Midway City Council  
7 September 2021  
Regular Meeting

Haynie Subdivision /  
Preliminary & Final Approval

## **CITY COUNCIL MEETING STAFF REPORT**

**Subject: Haynie Subdivision - Preliminary / Final Approval**

HAYNIE DENSITY REDUCTION SUBDIVISION PLAT - 25 AUG 2021

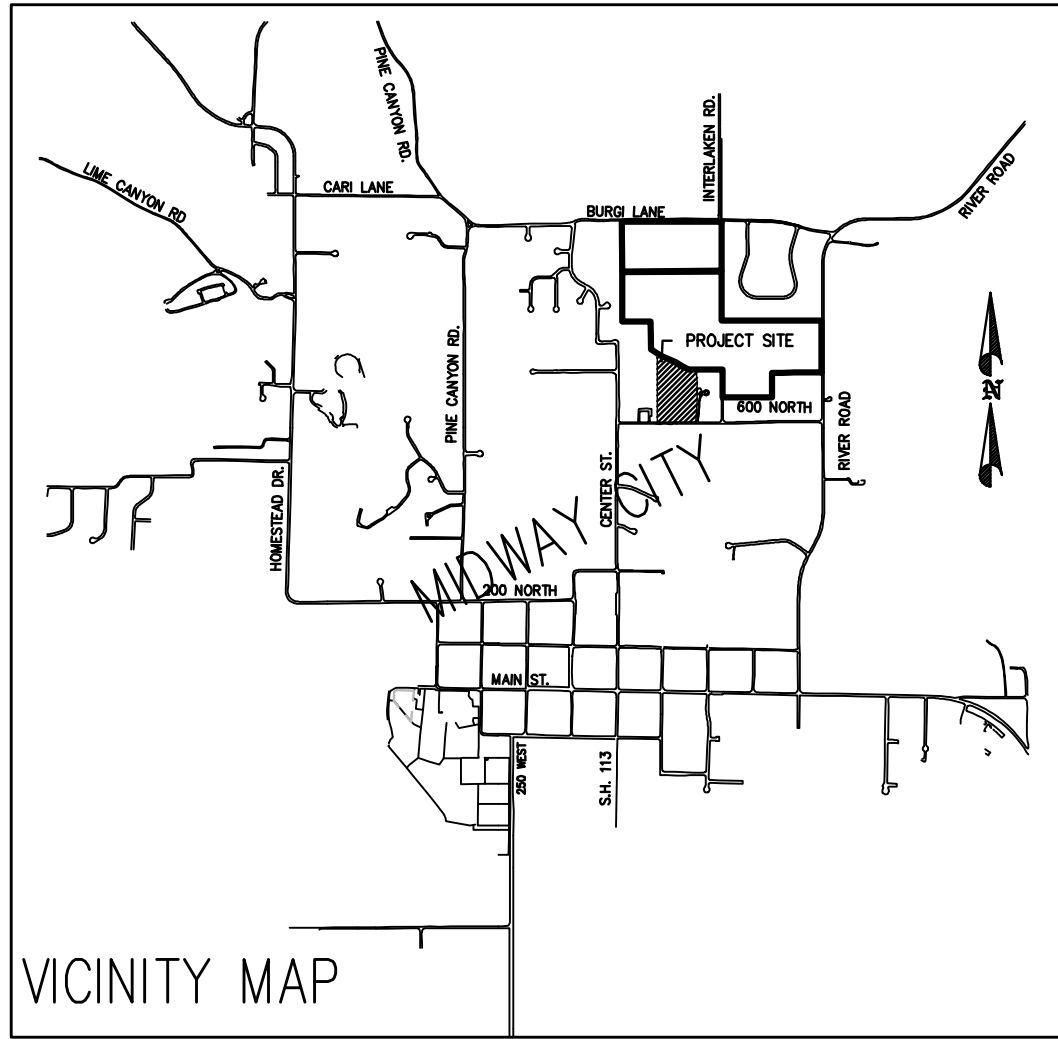
*Access* – Due to driveway offset requirements from other driveways and existing roads, staff has suggested that the applicant combine all three driveway accesses into one that is located along the common lot line between lots 1 and 2. The shared driveway will require a 30' wide easement that will need to be shown on the plat. A 20' driveway with 5' shoulders will be built in the easement to comply with the DRS driveway requirements. The plat should include a note that precludes the front two lots from being accessed directly from 600 North, all access should be from the shared driveway.

*Utility and road improvements* – 600 North was recently improved which included anticipated utility stubs for this property. The proposed plan changes the location of the stubs, requiring new utility road cuts for each utility to each lot. Wes Johnson, Midway city engineer, has recommended that the applicant pulverize the whole width of the road that falls between the properties east and west property lines and then repave the road.

## HAYNIE SUBDIVISION A DENSITY REDUCTION SUBDIVISION

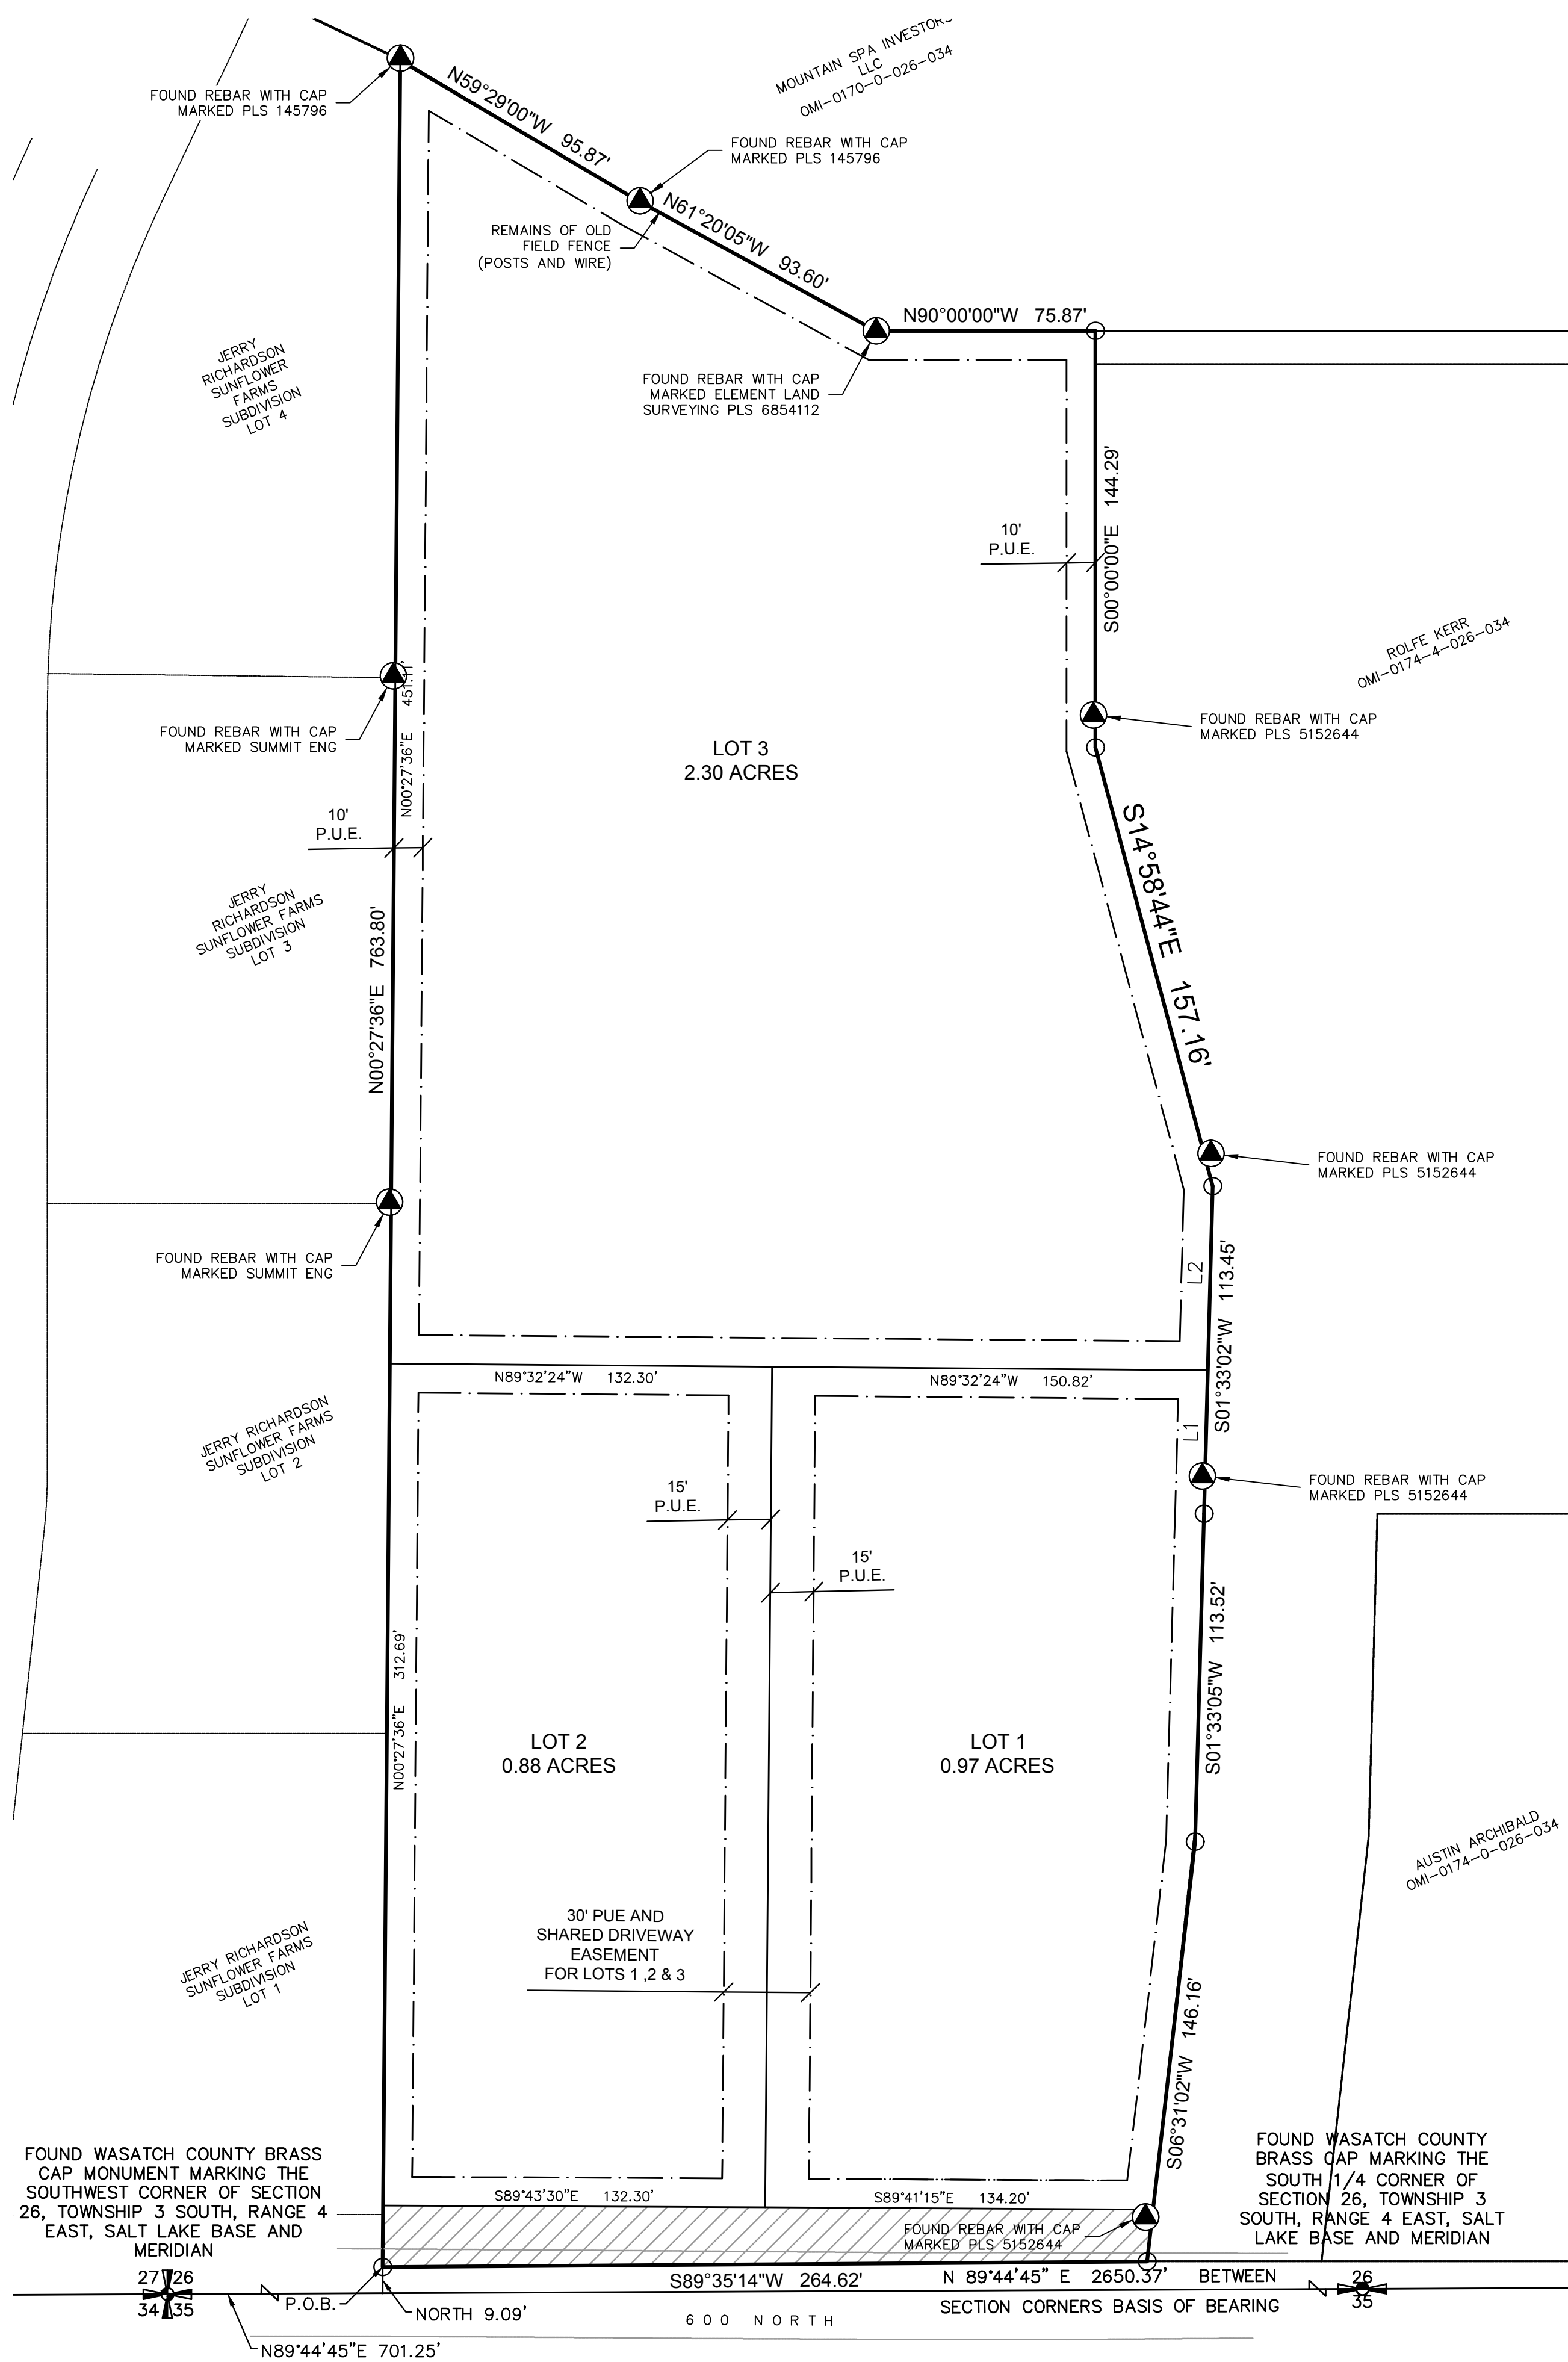
- The proposed development will be served from the Gerber Mahogany pressure zone.
- There is an existing 8" stub to the east end of the proposed development. This should be abandoned and the valve removed.

- The development must pave full width on 600 North where the asphalt is disturbed.
- There is a shared 30' driveway access off 600 North that serves all three lots.

- With no curb & gutter along 600 North, the existing shoulder will contain the drainage.

- The proposed subdivision will need to provide an irrigation service to each lot.
- There is an existing 4" PI stub to the east end of the proposed development. This should be abandoned and the valve removed.
- A min of 4" line will need to be installed to lot three to provide adequate service.
